SUBJECT: Forwards plant-specific details for ATWS mitigating sys
 actuation circuitry (AMSAC), in response to NRC safety
 evaluation of WCAP-10858-A, "AMSAC Generic Design...." Util
 selected Option 1, steam generator low level logic design.

Re: Docket No. 50-275, OL-DPR-80
Docket No. 50-323, OL-DPR-82
Diablo Canyon Units 1 and 2
Plant-Specific AMSAC Design

PLANT-SPECIFIC DESIGN DETAILS REGARDING
ATWS MITIGATING SYSTEM ACTUATION CIRCUITRY (AMSAC)
FOR DIABLO CANYON POWER PLANTINTRODUCTION

FIGURE 1

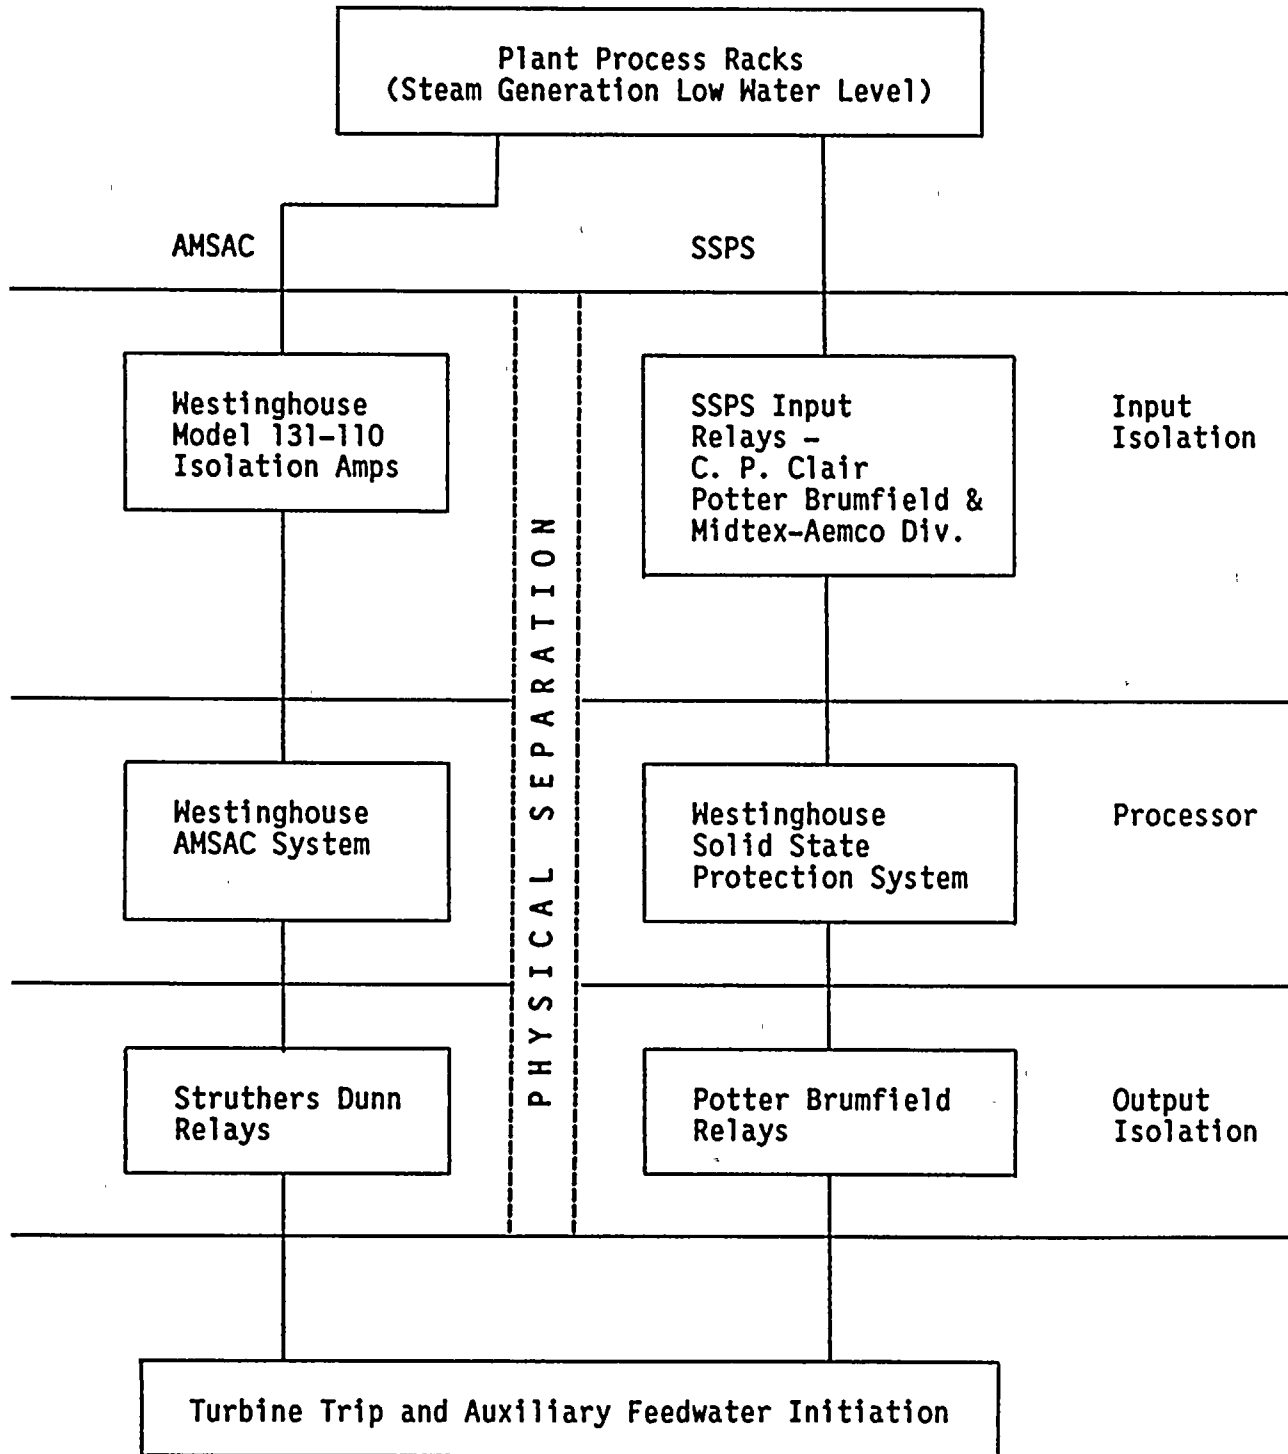
The plant-specific submittal should indicate the degree of diversity that exists between the AMSAC equipment and the existing Reactor Protection System. Equipment diversity to the extent reasonable and practicable to minimize the potential for common cause failures is required from the sensors output to, but not including, the final actuation device, e.g., existing circuit breakers may be used for the auxiliary feedwater initiation. The sensors need not be of a diverse design or manufacture. Existing protection system instrument-sensing lines, sensors, and sensor power supplies may be used. Sensor and instrument sensing lines should be selected such that adverse interactions with existing control systems are avoided.

Once actuated, AMSAC initiates the same turbine trip and AFW initiation signals as the SSPS (refer to Figure 1). This assures that actuation of the turbine trip and AFW circuitry is consistent with the existing plant design and that the protection system will operate to conclusion. Once the AFW flow has been initiated and the turbine tripped, deliberate operator action is required to override the actuation signals and return the plant to operation.

The diversity that exists between the AMSAC equipment and the existing reactor protection system is shown in Figure 1 and described below.

The existing reactor protection system is a Westinghouse solid state protection system (SSPS) based upon digital logic using discrete electronic components. Its inputs are isolated by C. P. Clair or similar relays, and its outputs are isolated by Potter and Brumfield relays.

The AMSAC system is a microprocessor-based system also provided by Westinghouse. Its analog inputs are isolated by Westinghouse Model 131-110 isolation amplifiers, which ensure that adverse interactions with existing systems are avoided. There are no digital inputs. The AMSAC outputs to the final actuation devices which initiate auxiliary feedwater flow are isolated by Struthers Dunn relays to ensure that credible failures within AMSAC will not degrade the AMSAC-actuated circuits below an acceptable level. All setpoints, time delays, logic functions, etc. pertinent to AMSAC are generated internally based upon the isolated analog inputs. These features provide additional diversity and independence from the reactor protection system.

FIGURE 2

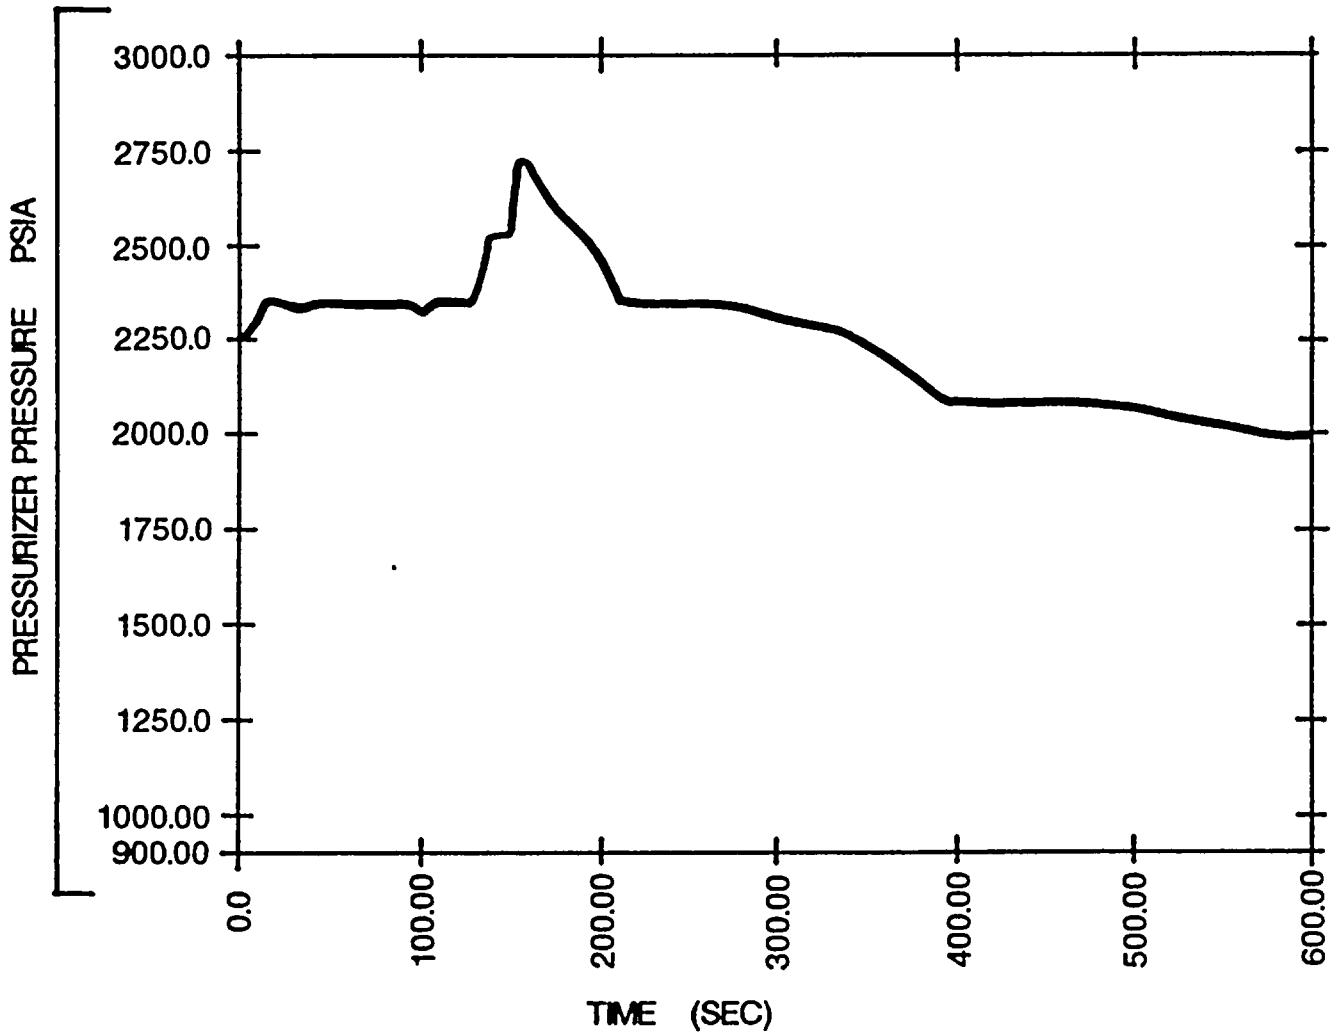
The plant specific submittal should state that operating bypasses are continuously indicated in the control room; provide the basis for the 70% or plant specific operating bypass level; discuss the human factors design aspects of the continuous indication; and discuss the diversity and independence of the C-20 permissive signal (Defeats the block of AMSAC).

Figure 2 shows that the peak pressurizer pressure on loss of feedwater at 70 percent without AMSAC is 2715 psia (with 2822 psia peak RCS pressure), which was less than the ASME Service Level C stress limit, 3200 psig. Thus, AMSAC is not required to actuate at or below 70 percent power to limit peak pressure in the unlikely event of a loss of normal feedwater ATWS event. However, in order to limit the amount of RCS voiding to that predicted, the C-20 power level will be reduced to 40 percent power. This is discussed in WCAP 10858P-A, Addendum 1, dated February 1987.
